STATE HIGHWAY 105 / JACKSON CREEK PARKWAY - PHASE 2

CONSTRUCTION PLANS

Comments provided by DPW Development Services

Comments provided by DPW Capital Projects

STATE HIGHWAY 105 / JACKSON CREEK PKWY. - PHASE 2 CONSTRUCTION PLANS
 ROADWAY IMPROVEMENT PLANS
 JACKSON CREEK PKWY. ROADWAY SECTIONS

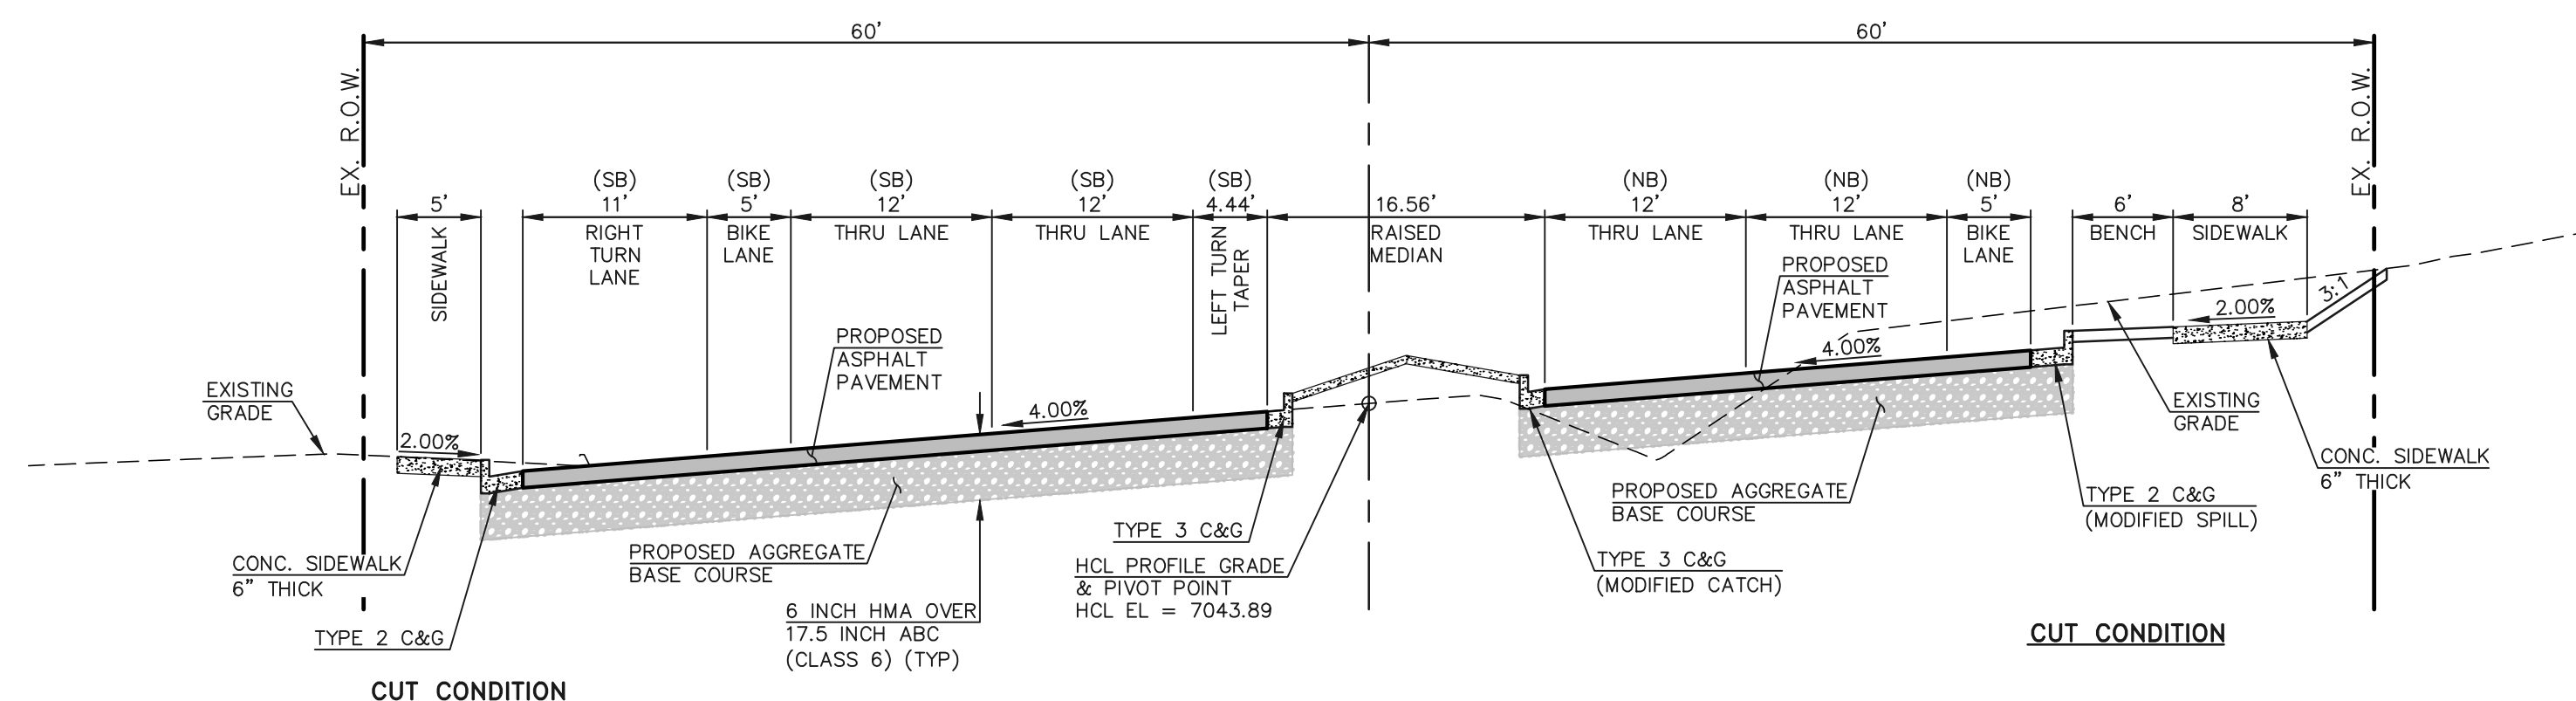
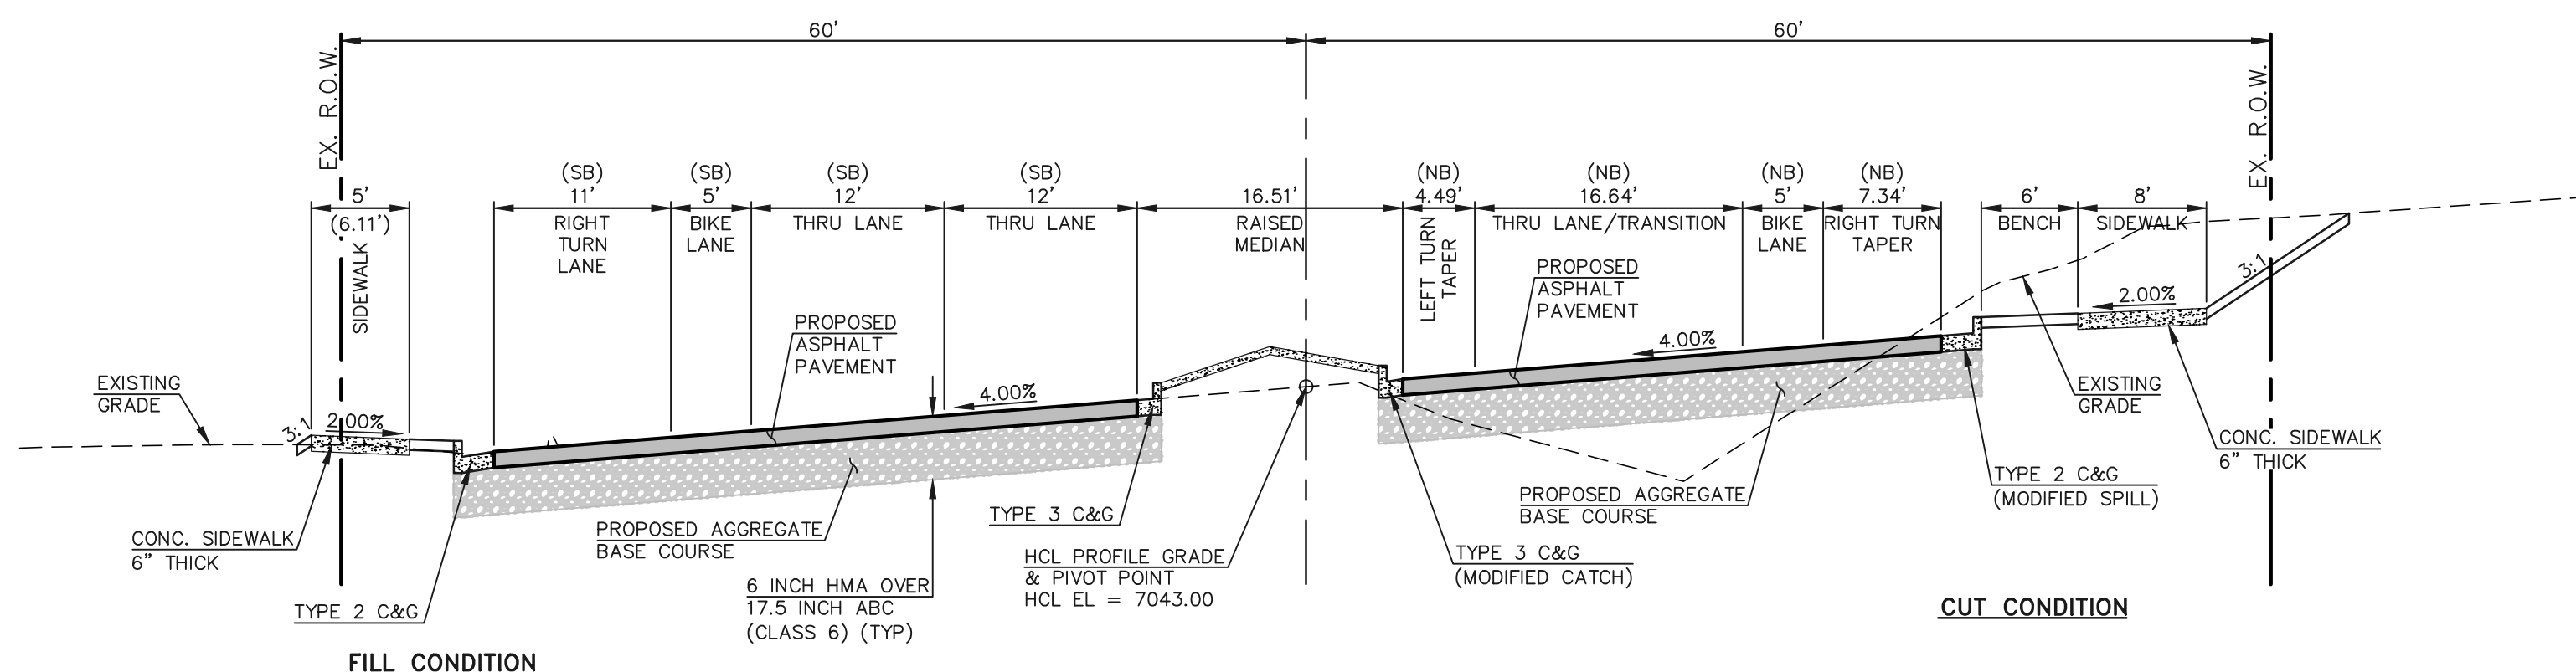
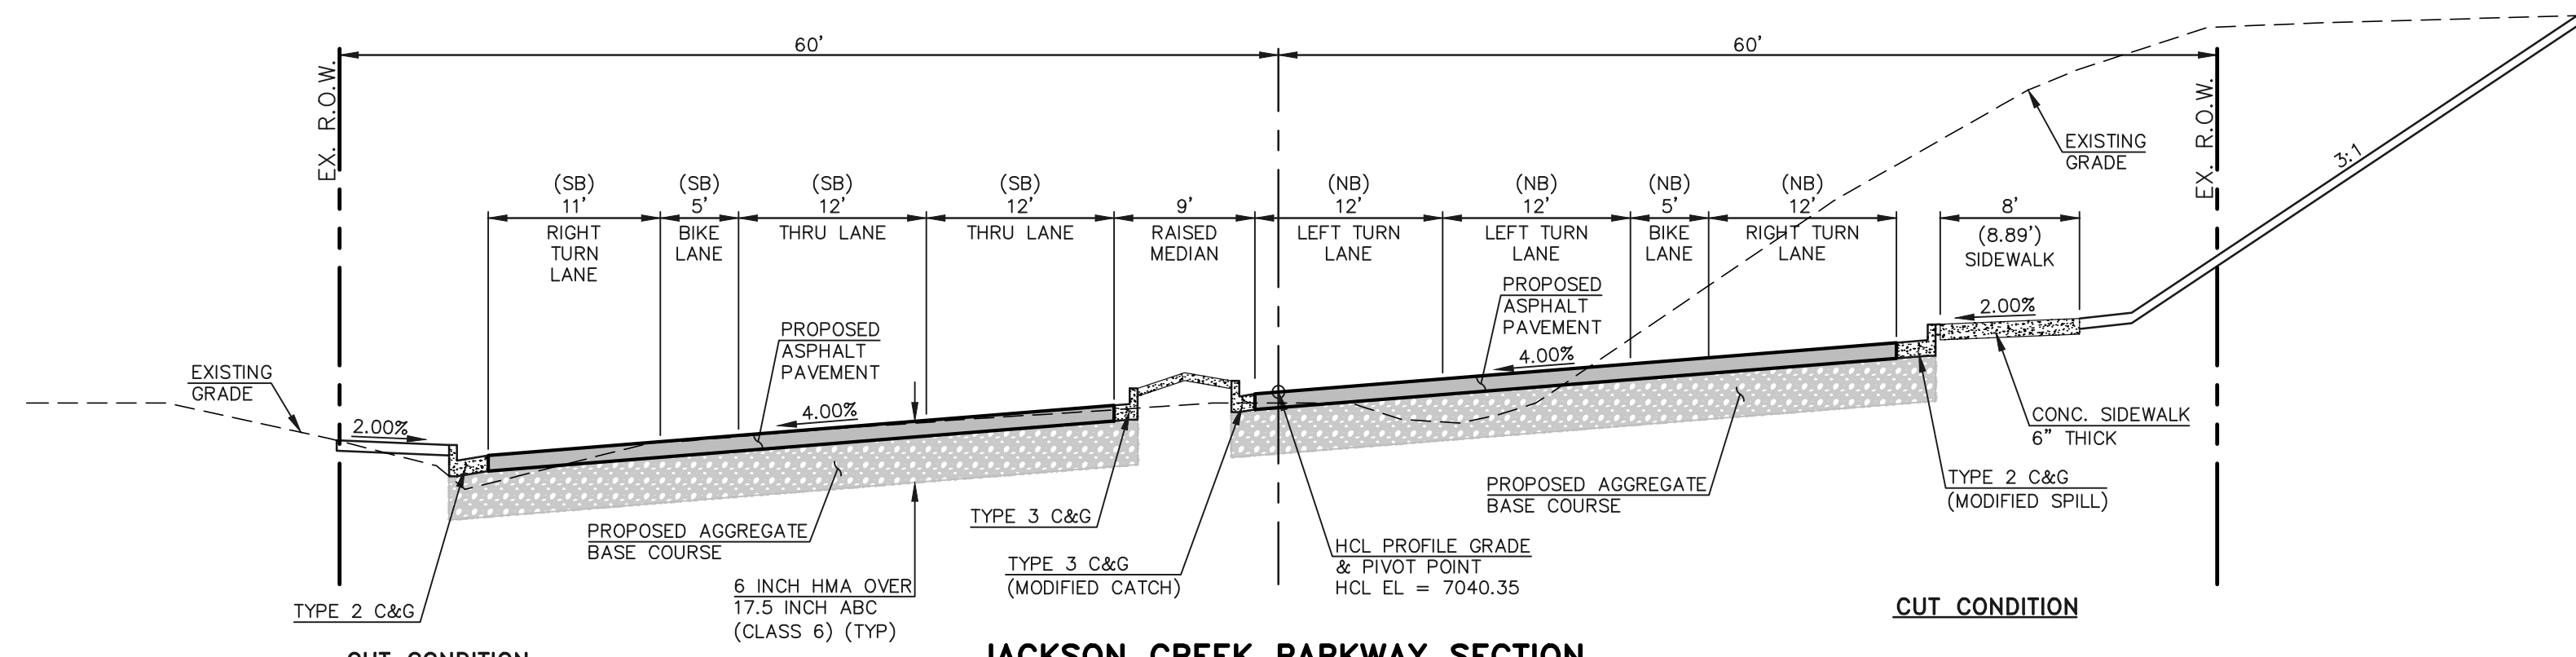
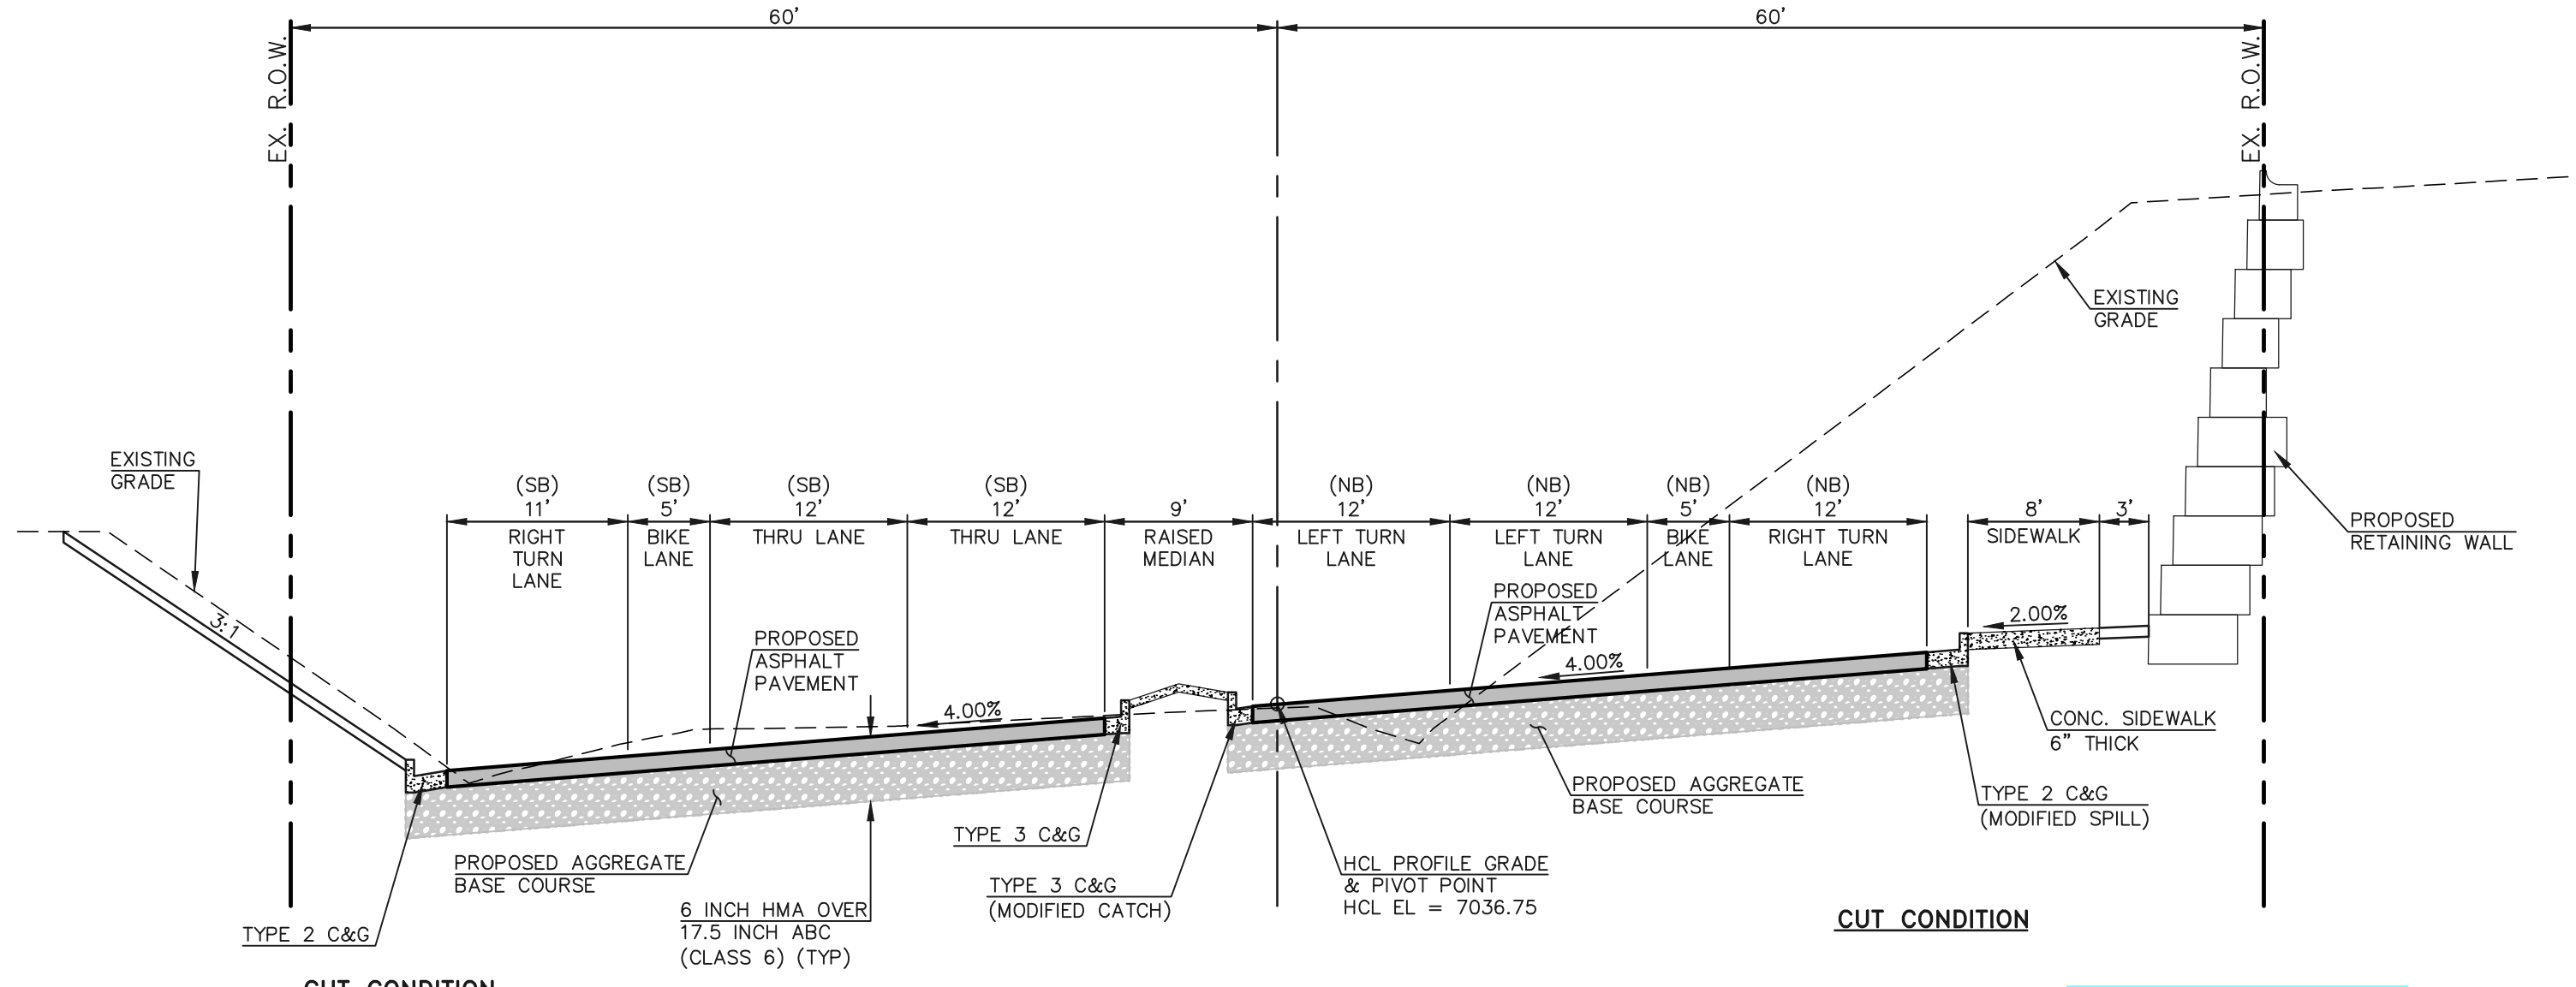
PROVIDE SECTION FOR HWY 105 (EPC). SHOW MILL & OVERLAY DEPTHS ON SECTION. ALSO SHOW ASPHALT AND BASE DEPTHS - SHOULD MATCH HWY 105 DESIGN DEPTHS FOR WIDENED AREA
